## MINUTES OF THE MEETING OF THE COMMISSION OF FINE ARTS HELD IN NEW YORK CITY, JANUARY 16, 1935

2. SKETCHES FOR MURAL PAINTINGS, ARCHIVES BUILDING: Under date of January 14, 1935, the following letter was received from the Office of the Supervising Architect, submitting Mr. Faulkner's revised sketches for the mural paintings for the Archives Building:

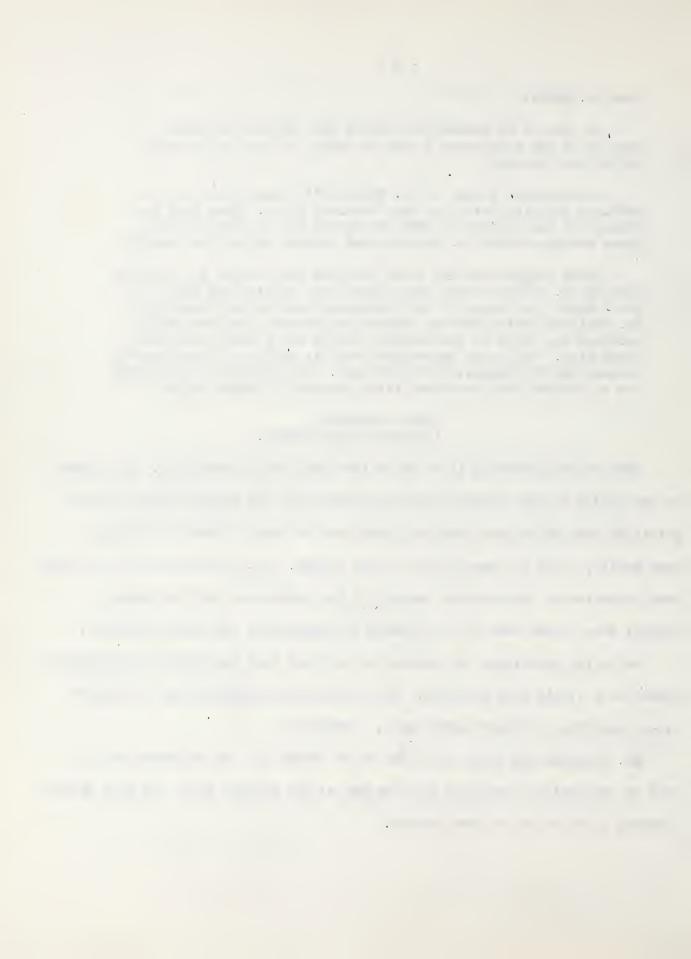
The Commission noted that on each of the sketches, namely, the Declaration of Independence and the Constitution of the United States, Mr. Faulkner had indicated standards of the colonies instead of the sculptural figures shown in the previous sketches.

Photographic copies of Mr. Faulkner's compositions for the Archives Building have just been received by me. They show his studies of the subject to date, embodying the suggestions and ideas developed when Mr. Faulkner was present at our last meeting.

These suggestions and other elements and changes put into the work by Mr. Faulkner have very effectively carried the work to a point where the wishes of the Commission seem to have been met. Mr. Faulkner feels that the various suggestions have been helpful, enlarged the scope of the subject treated and I think they have saved time. It is my impression that his studies can be approved to date by the Commission at this time. The approval would enable him to proceed with completed final studies at larger scale.

As to the paintings, the suggestion was made that the figure of Washington should be a little more animated. The sketches were approved and the Supervising Architect informed accordingly. (Exhibit A)

The sketches were approved.
